## Government of India Ministry of Environment, Forests and Climate Change (FC Division) \*\*\*\*\*

Subject: Proposal for diversion of 466.592 ha forest land in favour of Airport Authority of India Kota for Construction of New Green Field Airport Kota, District-Bundi in the State of Rajasthan.

Google Map showing the Non-forest land in the instant proposal is falling within the Forest land.

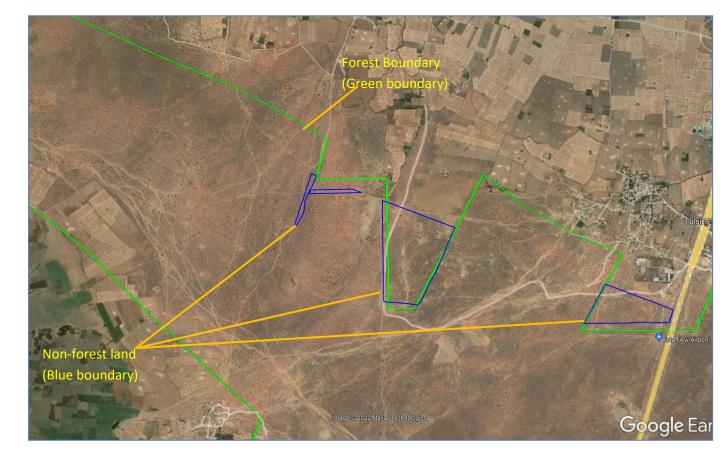
- iii. In response to the observation raised vide Sr no (iv) of Ministry's letter dated 17.06.2022, it is informed that 33.408 ha land is recorded in the name of Urban Improvement Trust, Kota and it is not any notified deemed forest whereas the digital forest boundary available on Rajasthan forest department website shows that some part of Non-forest land in the instant proposal is falling within the forest boundary. In this

regard, a copy the extract portion of Google imagery is enclosed in **Annexure for** ready reference. Further the State Government in response to a specific query at sr no. (v) of letter dated 17.06.2022 has mentioned that the digital boundary of the forest land is correct. The above details are therefore contradictory to each other. This need clarification with supporting documents from Govt. of Rajasthan.
